802.3cu D1p0

TDECQ-SECQ considerations.

In support of comment #15

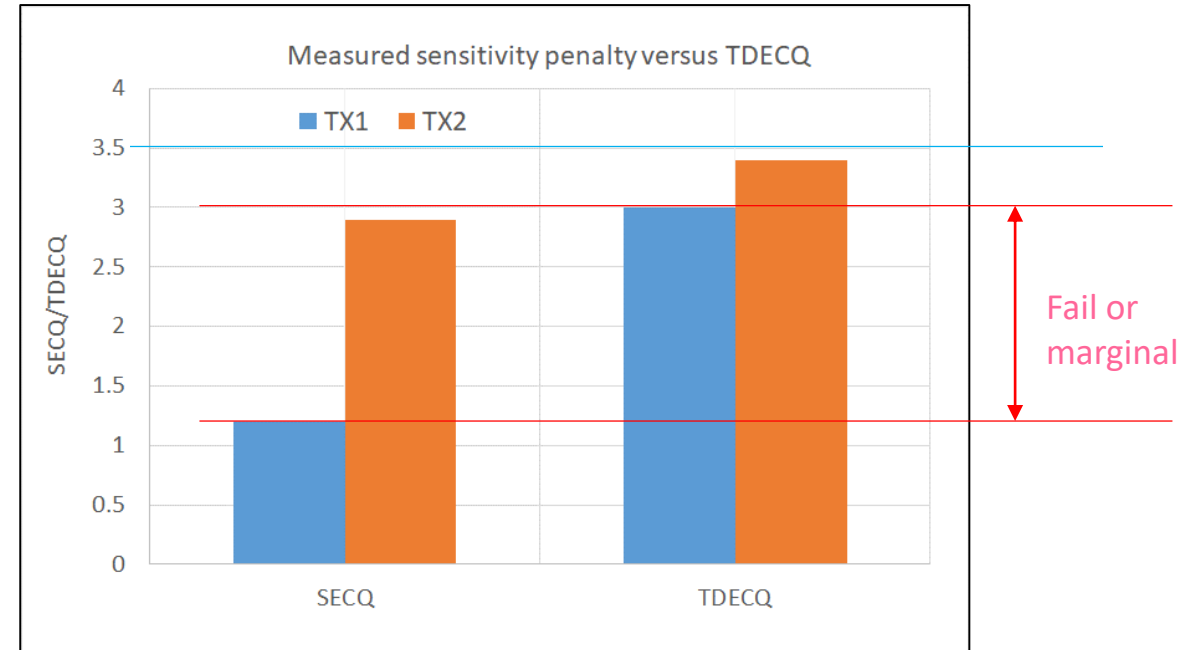
Is TDECQ-SECQ an accurate metric ?

Because rely on the difference of two parameters taken under different propagation conditions.

Considering the TDECQ reference trasnmmitter, TDECQ-SECQ penalty would more easily diverge from the real receiver under propagation condition.

- SECQ (TDECQ at $km=0$) would have a better fit with real receivers, and less results variation because the 1% threshold optimization will keep it almost stable.
- While TDECQ at maximum dispersion would probably need more than 1% threshold adjustment, result is expected to be less stable considering the current .

Thus TDECQ-SECQ cannot be a very accurate metric.

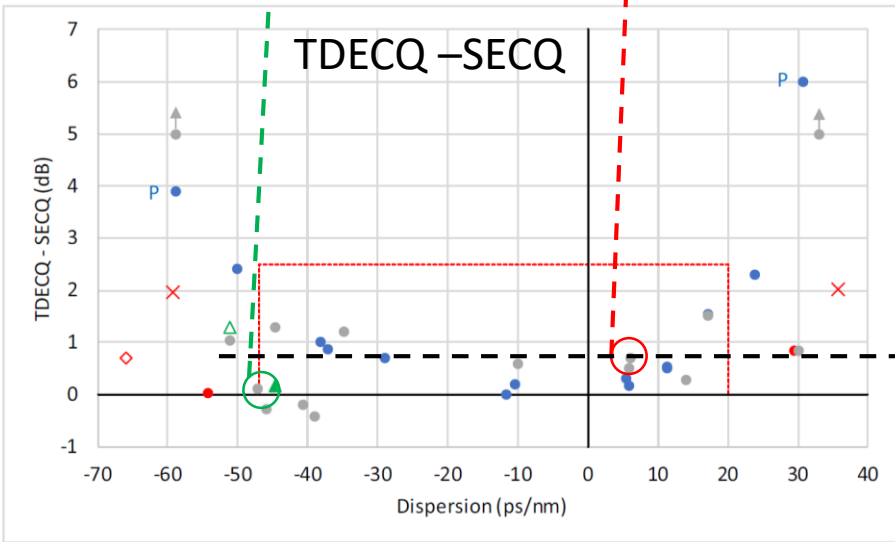
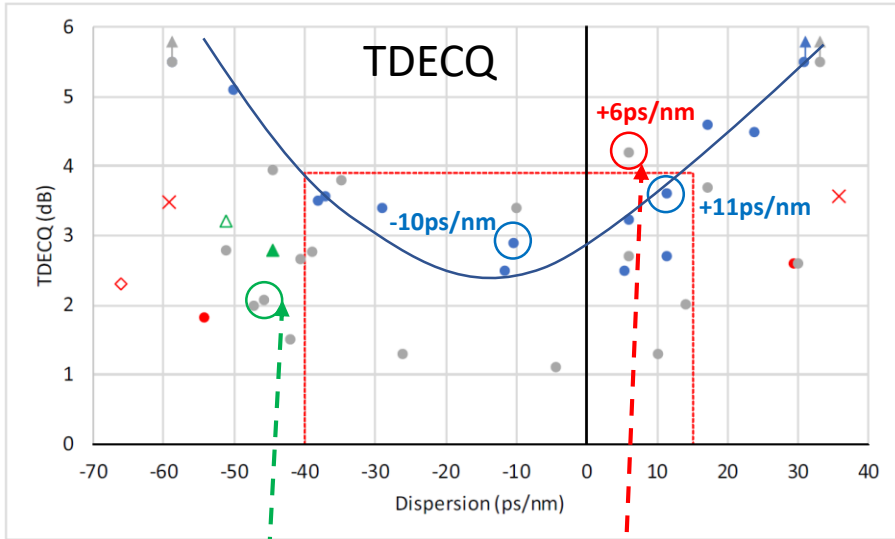
TDECQ-SECQ need to be carefully specified.

For 400GBASE-LR4, the chromatic dispersion penalty has been implicitly set to 0.1dB, considering that 3.4dB TDECQ was assumed for same types of transmitters over shorter distances.

Then, if we want to define a different TDECQ-SECQ value than 0.1dB, also $TDECQ - 10 \cdot \log(C_{eq})$ will have to be considered too, starting from a lower distortion requirement (see next slides).

TDECQ-SECQ can potentially penalize transmitters which can still meet the absolute TDECQ at the worst case fiber propagation conditions, but fail just this new parameter. Its impact as unique parameter driving link failure has never been shown.

If TDECQ-SECQ will not be carefully quantified, what can then happen then is the absurd situation that after propagation tests a 'good' transmitter ends with lower TDECQ with respect a worse one, but just fails the new TDECQ-SECQ metric ...

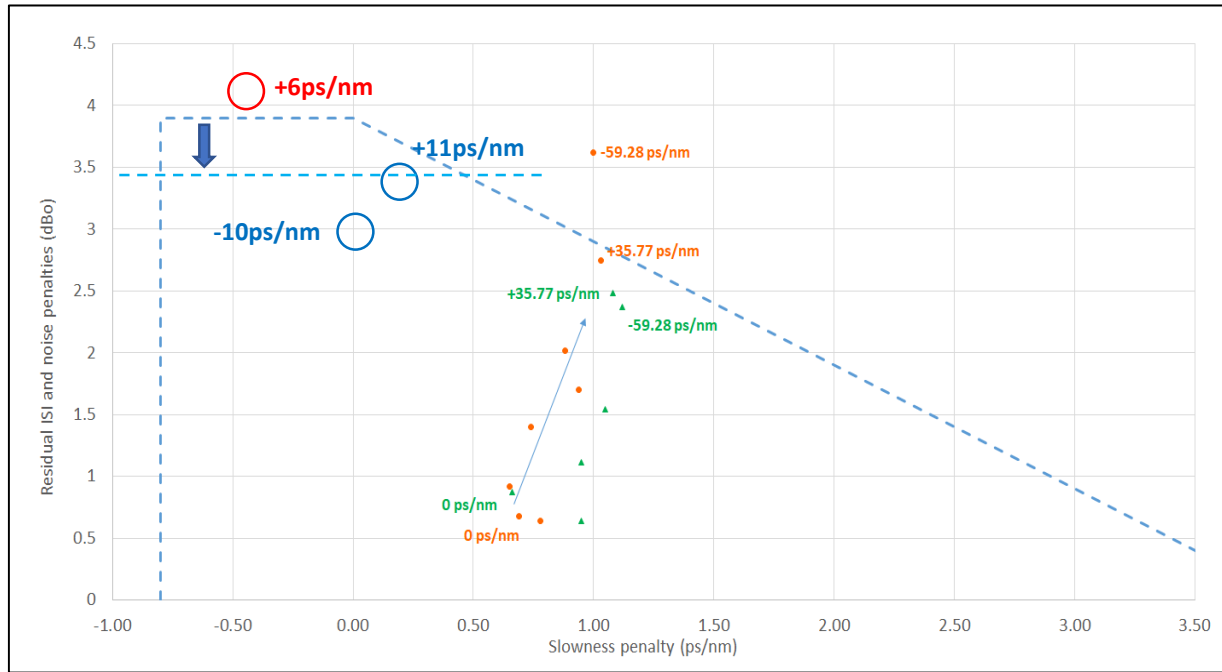
TDECQ – SECQ does not discriminate pre-distorted transmitters.

Into [stassar 3cu 01 0919](#) a TDECQ chart with scattered results was reported (slide 6), observing that the TDECQ-SECQ chart (slide 7) can be scattered was more consistent to quantify the CD penalty.

However, scattered TDECQ values can be considered normal if the transmitters were pre-distorted to deal with CD.

This is why transmitter TDECQ-10Log(Ceq) (see [mazzini 3cd 01d 0718](#)), has also to be tested together with TDECQ.

Based on same charts, the example is showing that two point at low TDECQ-SECQ have quite different TDECQ, which make clear that TDECQ-SECQ is not going to catch pre-distorted transmitter which distortion cannot be equalized.

While TDECQ-10Log(Ceq) will catch this difference, having being defined for it.

Low
TDECQ-SECQ

○ High TDECQ and low TDECQ-SECQ (so high SECQ) -> Distortion penalty -> high TDECQ-10Log(Ceq)

○ Low TDECQ and low TDECQ-SECQ -> Distortion penalty -> Low TDECQ-10Log(Ceq)

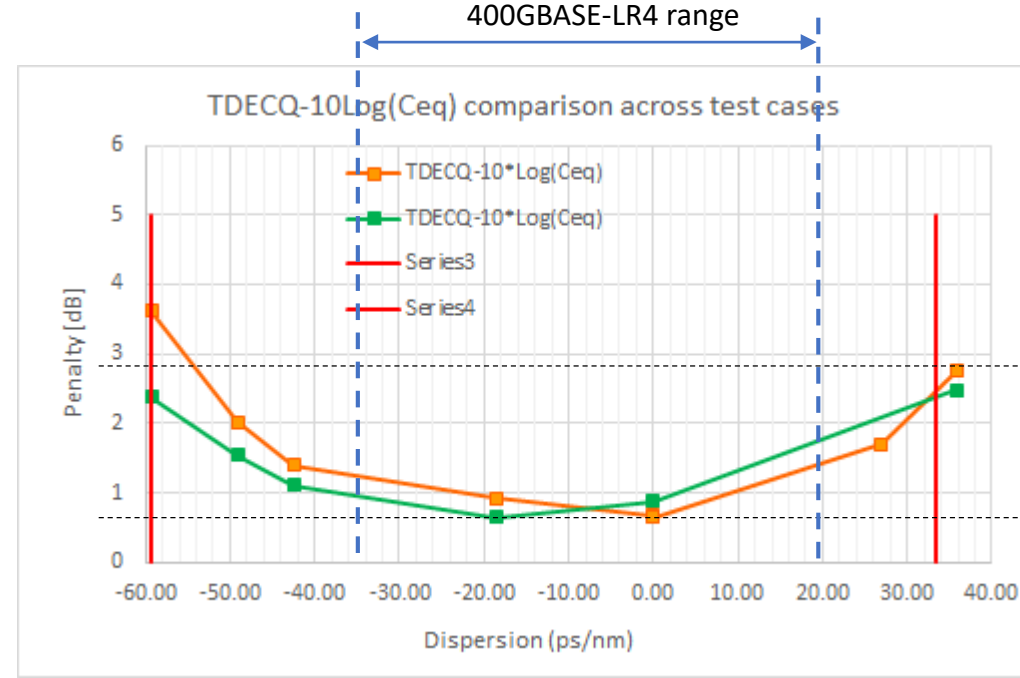
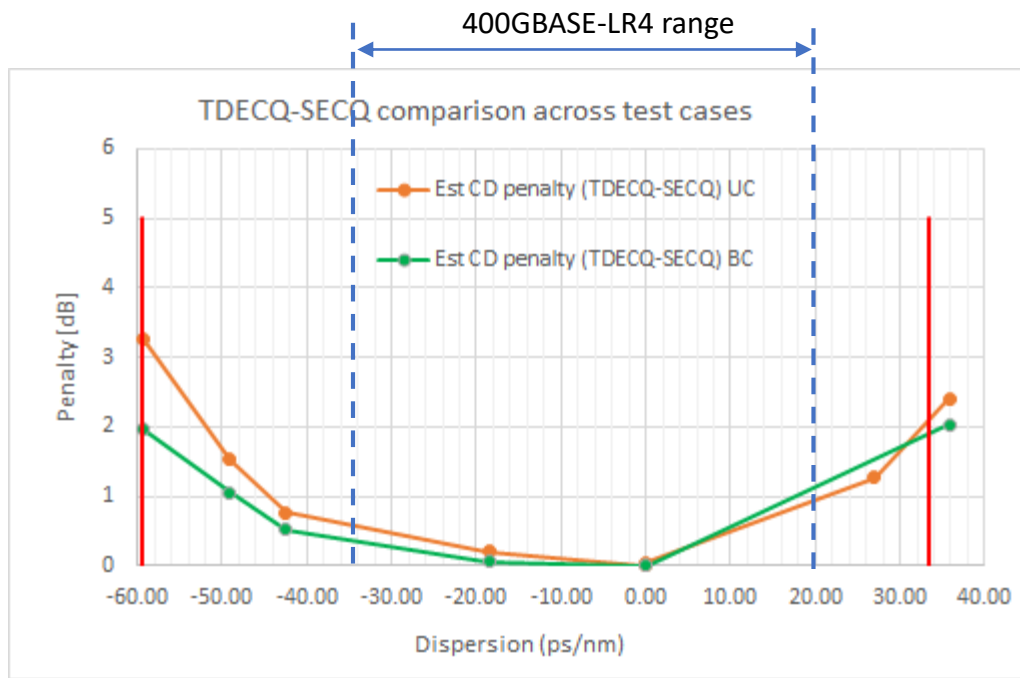
Plot of dispersion penalty results from [mazzini 3cu adhoc 082119](#) for uniform level spacing and bottom compression. Orange and green showing CD penalty trend being partially equalized and improvement due to bottom compression.

Red and Blue circles are estimations of worst cases 100G Lambda MSA and [yu_optx_01a_0319](#) TDECQ and TDECQ-SECQ measurements from previous slides.

Because referring to very small dispersion, both cases seems heavily pre-distorted.

Most of the chromatic dispersion penalty goes in TDECQ-10*Log(Ceq) penalty (vertical axis).

To ensure interoperability cases, one option would to reduce TDECQ-10Log(Ceq) limit, by not aligning it with TDECQ.

Figure 151-4—TDECQ conformance test block diagram

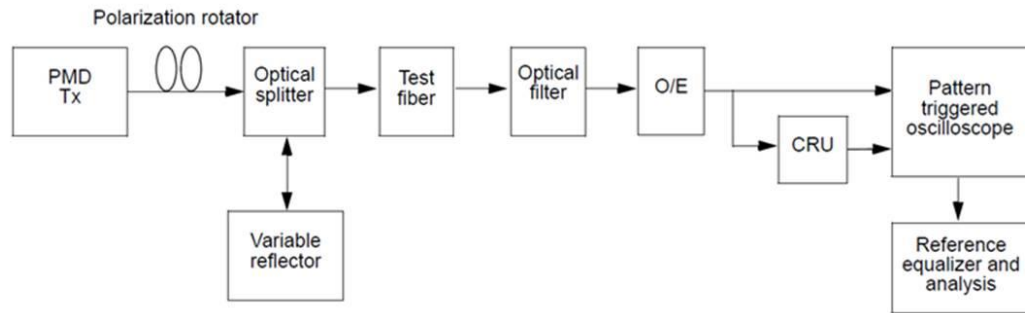
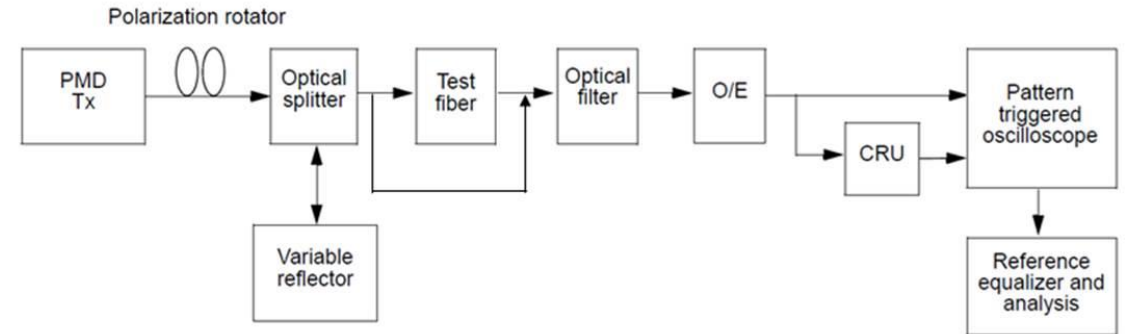
TDECQ-SECQ is a time consuming (expensive) test.

TDECQ-SECQ rely on a parameter (SECQ) that is been NOT defined as a transmitter parameter, but is a receiver input requirement, used to calibrate stressed receiver sensitivity.

So, to verify this requirement, there'll be the need to verify BOTH the fiber propagation at CD limits AND the 0 ps/nm condition.

Potential TDECQ-SECQ conformance test block diagram

In manufacturing it will require a controlled environment in which, not only the TDECQ at the worst chromatic dispersion will have to be tested (and one can choose it own corner case test, once defined it in case), but ALSO the transmitter SECQ, run two tests: one for SECQ with 0 ps/nm dispersion and then one for TDECQ with worst case dispersion – doubling the testing time and then costs.

For multi-wavelength PMD (like 400GBASE-LR4) this will have of course more impact.
